SERVICE NOTICE**NUMBER:** SN-010 (GARMIN Service Advisory No. 0933 Revision A Attached.)**DATE:** 04/23/2012**REVISION:** 01**SUBJECT:** GARMIN G1000; 0933 Revision A**SUMMARY**

SERVICE ADVISORY

NO.: 0933 Revision A

SUBJECT: System may select NAV2 as navigation source during approach

Figure 1. LOC 2 Selected

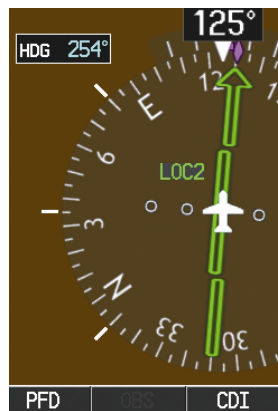
If the CDI Synchronization function is enabled, the system may select NAV2 as the navigation source for the CDI when automatically switching from GPS to LOC during a localizer or ILS approach.

The pilot may disable the CDI Synchronization function if desired, thus ensuring that the navigation source for PFD1 transitions to LOC1 and PFD2 transitions to LOC2 during a localizer or ILS approach.

Garmin plans to include a change in future software releases that will transition the navigation source for each PFD to the LOC that is associated with the flight-director-selected side, when CDI Synchronization is enabled.
